**MONTGOMERY COUNTY PLANNING DEPARTMENT**  
 THE MARYLAND-NATIONAL CAPITAL PARK AND PLANNING COMMISSION

**Staff Report: Project Plan Amendment 91994004B, Preliminary Plan 11995042A,  
 Final Water Quality Plan and Site Plan 820070220 Clarksburg Town Center**

**REVIEW OF:** Compliance Program: Clarksburg Town Center Project Plan #919940040, Preliminary Plan #119950420 and Comprehensive Site Plan #820070220 which incorporates Site Plan #819980010 and #820020140. The application has been submitted to fulfill Stage III of the Compliance Plan which calls for all of the elements agreed to by the parties to the mediation to be incorporated into an amended overall Project Plan, Preliminary Plan, and a new site plan that covers the entire development. Requests approval for 194,720 gross square feet of commercial development, (including up to 48,000 sf of specialty retail within live/work units); and 1,213 residential dwelling units, including 152 MPDUs, and a waiver to permit a reduction of parking spaces for the west side; on approximately 270 acres. Located at the southeast quadrant of the intersection with Clarksburg Road and Snowden Farm Parkway in the Clarksburg Master Plan

**APPLIC

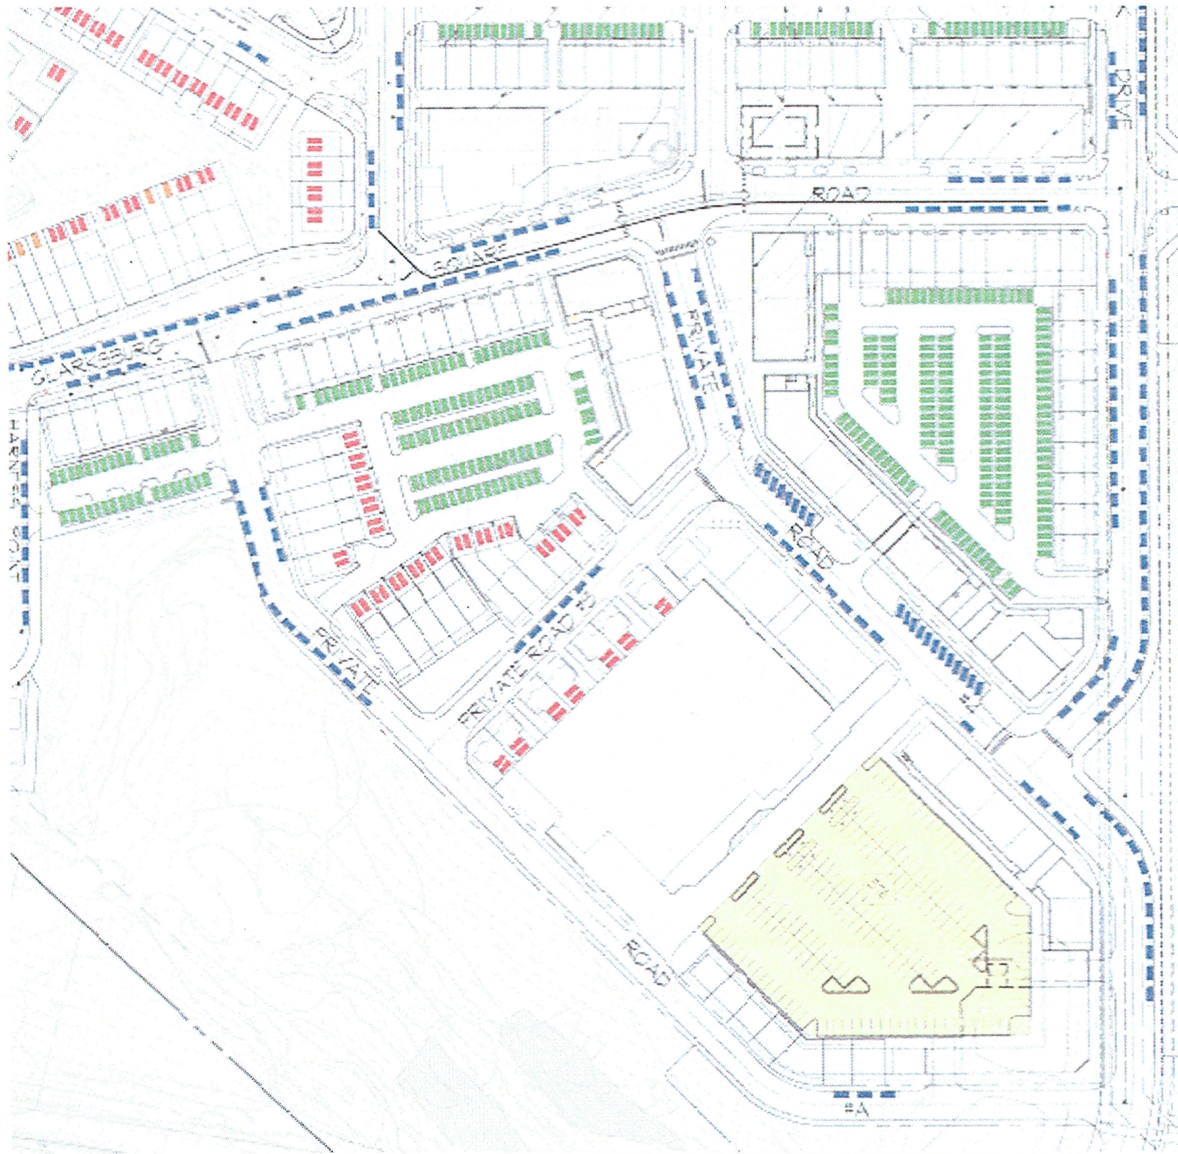
The community is concerned that the parking structures are integral to the pedestrian oriented, urban design of retail center and were an essential part of the Compliance Plan. Changing the

parking structure in front of the grocery store from three levels to two and replacing the other parking structure with a surface lot has also significantly impacted the design of the retail core by reducing the depth of the retail stores from 60 to 50 feet, increasing the need for retaining walls, and causing the retail street to be designated “private” rather than “public” to allow the use of angled, rather than parallel parking. The community is also concerned that a shortage of parking will have an impact on the success of the retail area.

**Staff Recommendation: Staff recommends that a secondary access to the grocery store be provided from Public Road ‘A’ (currently shown as Private Road #1) to offer increased visibility and assistance with activating the street-level retail; changing the proposed asphalt sidewalks to brick as found in other town centers; and restoring the two parking structures envisioned in the approved Plan of Compliance.**

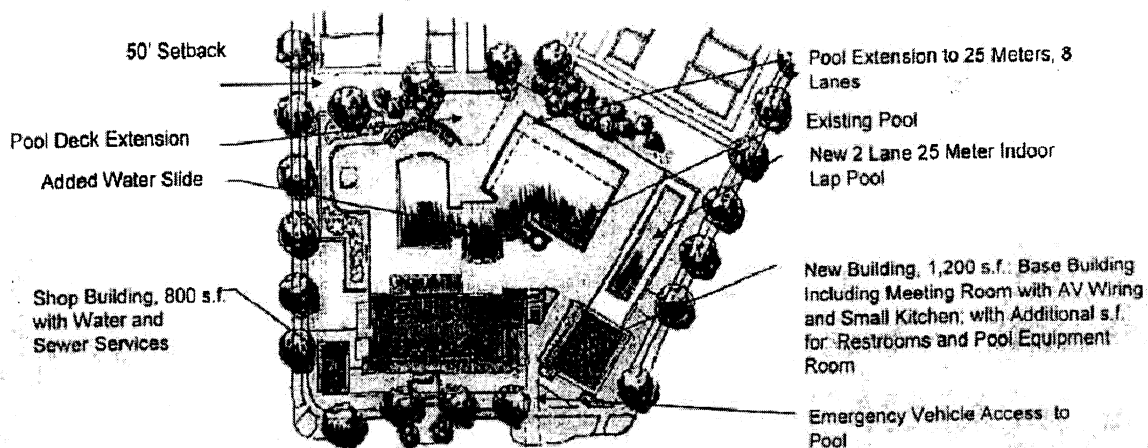
- 1) Extension of the outdoor pool to 25- meter length and add additional width to accommodate (7) eight foot wide lanes, one with a slide, and (6) lanes for regulation MCSL meets
- 2) Addition of an 800 square foot building to house a snack bar,
- 3) Addition of a 1,200 square foot building to be used for movies and other community functions,
- 4) Addition of a building to house a year-round, two-lane lap pool,
- 5) Additional parking to serve the facility.

After the Plan of Compliance was approved, members of the community voiced concerns over the operational requirements and maintenance issues associated with a lap pool. Particular concerns included the need to provide costly lifeguards year round and the worry that such an enclosed, heated facility might have problems with mold. Newlands presented an alternative concept on 1/15/08 that proposed to eliminate the lap pool in favor of an all-sports court that would have the advantage of meeting the recreational needs of teenage residents. Several other modifications, such as removing the 800 square foot building altogether and relocating the square footage to one of the other buildings, were also considered. However, the community could not get a commitment from the Applicant as to just what they would provide in terms of fit-out for these new buildings, so the resident group opted to move forward with the facilities as submitted in the Plan of Compliance.

**Staff recommendation: Staff recommends deleting the lap pool in favor of the all-sport court and eliminating the small building. The Applicant should be responsible for fitting out the sport-court and the community building (furniture, av system) with the specifics regarding what the applicant must provide with respect to fit-out being determined by certified site plan. All other improvements to the pool and wading pool should move forward as anticipated in the Plan of Compliance.**

Current location of future library site as of May, 2008

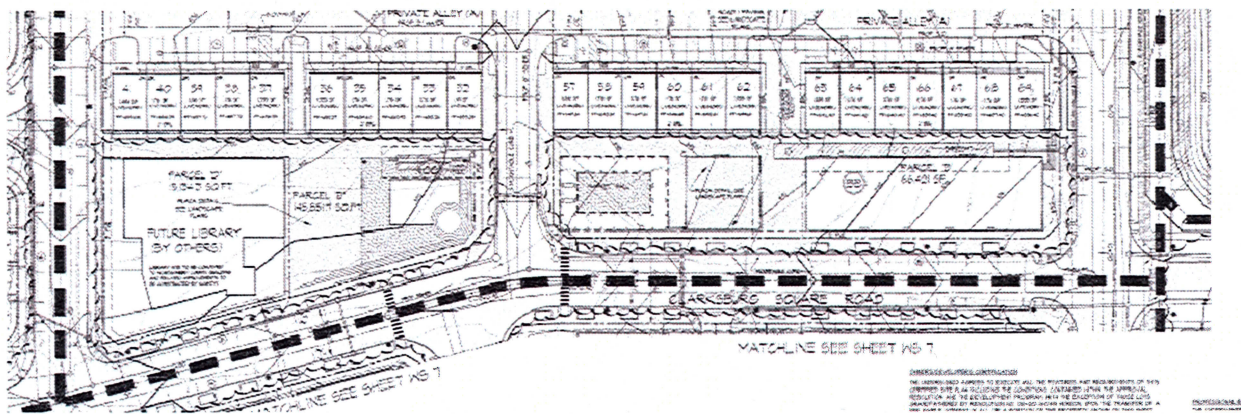
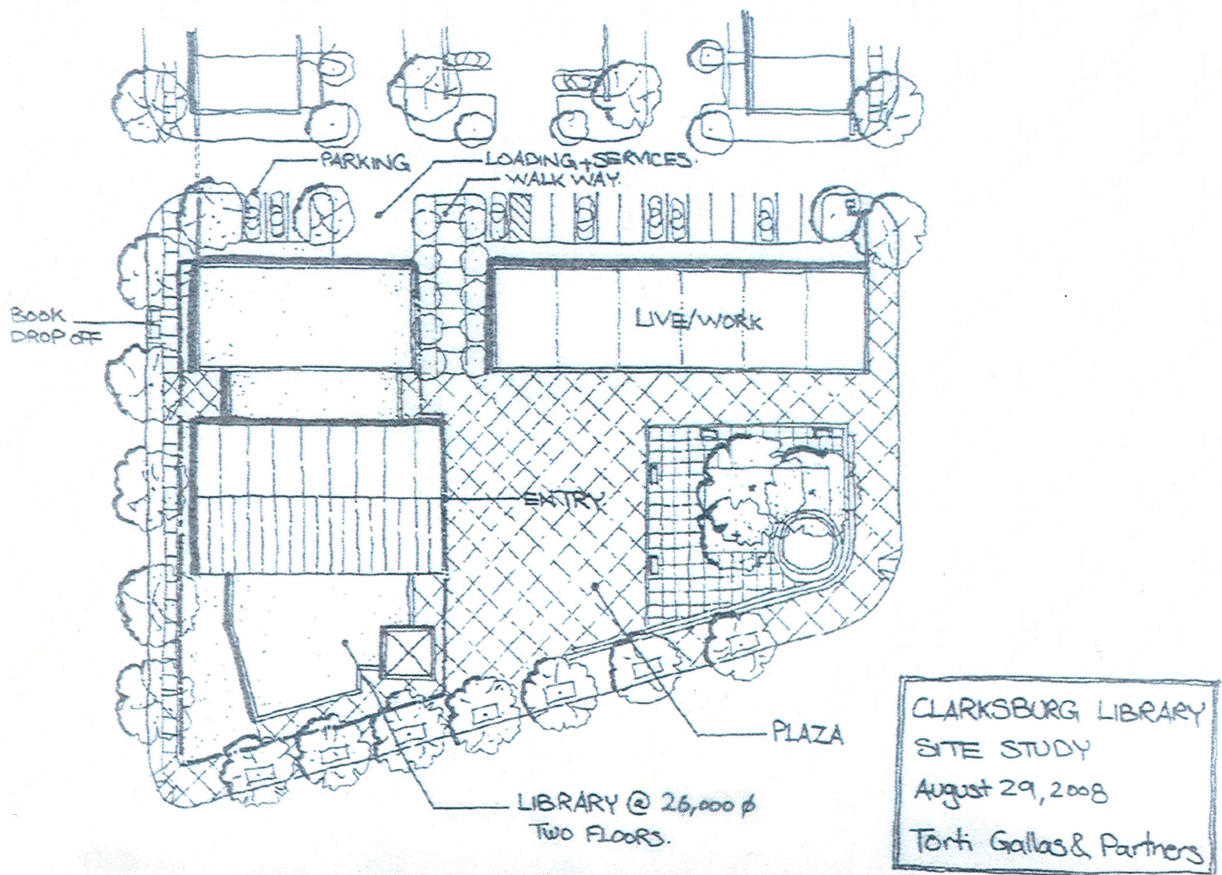
The first image (below) depicts the future library site and building originally submitted by the Applicant, which is very similar to the Plan of Compliance. The second image was presented by the Applicant as part of its resubmission on September 5, 2008 in response to the DRC comments. It indicates a larger footprint that would necessitate the removal of five live/work units (one of which would simply be relocated southward for a net loss of four) and provides a book drop-off on the public road with loading and three parking spaces (including handicapped).

The community as a whole has supported the location of the Library shown in the Plan of Compliance. Although recognizing that the site might be too small to provide a full service library, the alternative would require the removal of four 4 live/work units, which was seen as contrary to the Plan of Compliance.

The Library is a key feature to the success of the town center and should be designed in a manner that complements the future retail center, civic plaza and Town Green. Staff supports a larger library site with a revised building layout to better accommodate MCPL's needs. Staff does not support a surface parking lot immediately adjacent to the library because it would break up the street wall and would require reorientation of a number of the one-family attached units.

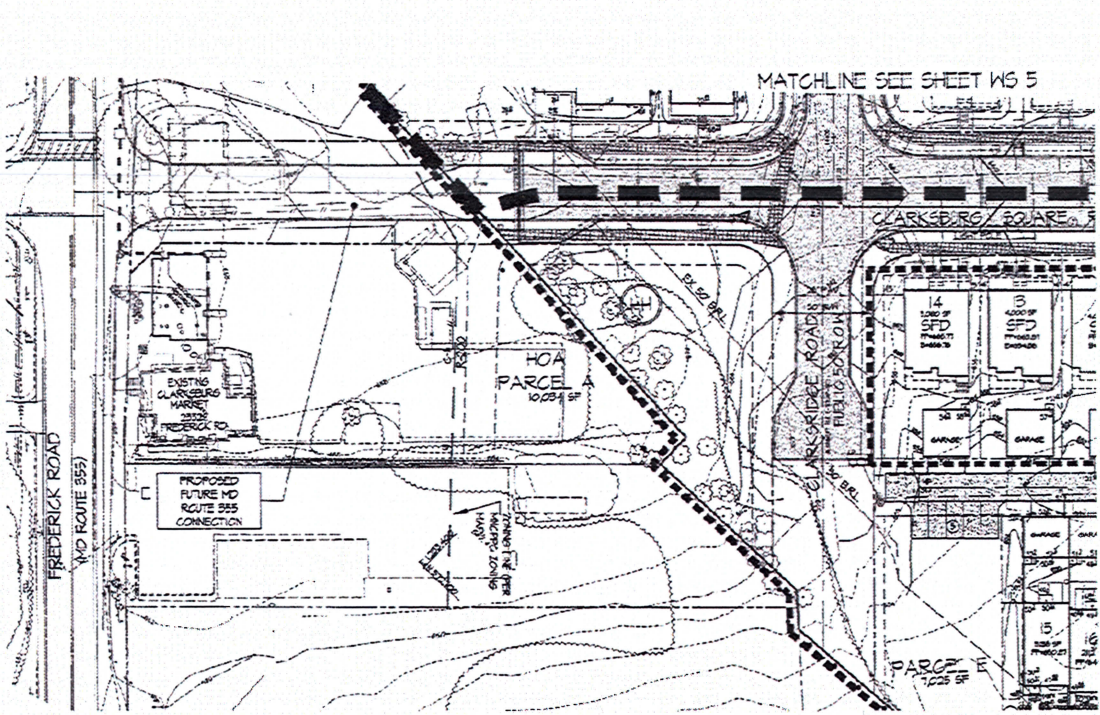
Applicant has submitted a concept that indicates the realignment of the road, relocation of the house and reconfiguration of the site elements on the Clarksburg Store/Grill site.

Image above indicates the previous concept showing the house to be retained and the road alignment moving to the south of the house. The image below indicates the current proposal.

Staff supports the road connection and relocation of the Horace Willson house as now being proposed, even though it is not technically consistent with the Plan of Compliance, because it results in a better alignment of the road yet keeps the house in the Historic District in a similar location facing Rt.355. It is staff’s understanding that the Applicant will enter into a participation agreement with the Department of Transportation regarding this project, however DOT is not responsible for the relocation of the house.

**Staff Recommendation: To permit the alignment of the future connection of Clarksburg Square Road to MD 355 so that it aligns with Redgrave Place and provides a vehicular connection through the Clarksburg Historic District. The Applicant shall relocate the entire Horace Willson house in order to accommodate the vehicular connection. The Applicant will be required to obtain a Historic Area Work Permit (HAWP) for the infrastructure and relocation of the house.**

### **V. Location of Bike Path**

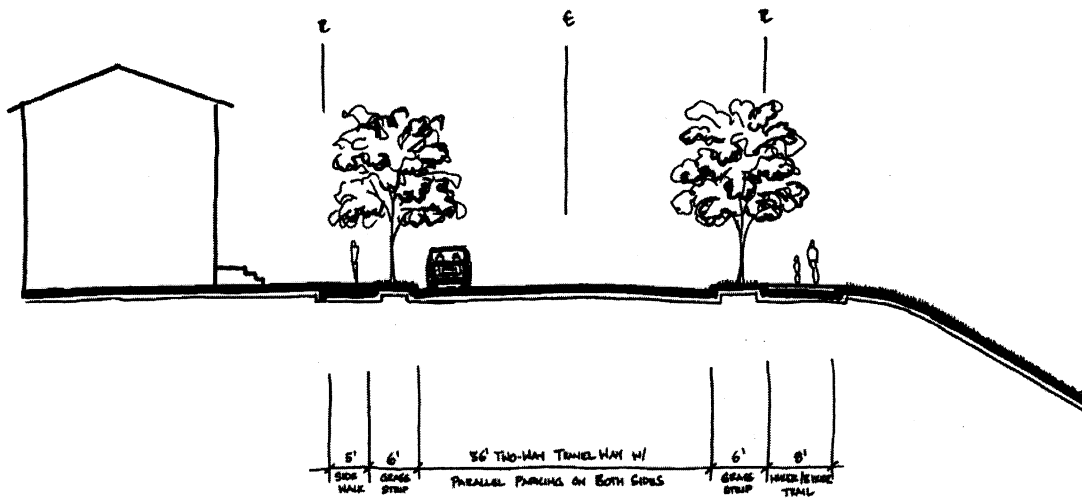
The location of the 8-foot-wide hard surface bike path was submitted and approved on the east side of Overlook Park Drive and adjacent to the Greenway during the site plan review for Phase I (819980010). The trail is intended to provide an important bicycle and pedestrian link through along the north south access from MD 121 to Stringtown Road and will connect in the future to the planned Greenway trail throughout Clarksburg. Originally, this hardscape path was going to be located within the greenway in Clarksburg Town Center, but environmental staff found this to be environmentally unsound, so the trail was moved to its current site along Overlook Park Drive. Although DOT had agreed to this location with the earlier site plan approvals, they no longer want to be responsible for maintaining the trail. This resulted in a recommendation to narrow the right-of-way for Overlook Park Drive from 60 feet to 53 feet and to place the bike path within a separate HOA parcel or make it part of the Greenway to be owned and maintained by the M-NCPPC.

Staff Recommendation: Staff supports the MCDOT-approved 53-foot right-of-way for Overlook Park Drive. This section will consist of a 5' planting strip, 36' of pavement, 6' planting strip, 5' sidewalk, and 1' offset. The 8-foot greenway bike path will be outside of the right-of-way and should be maintained by Parks..
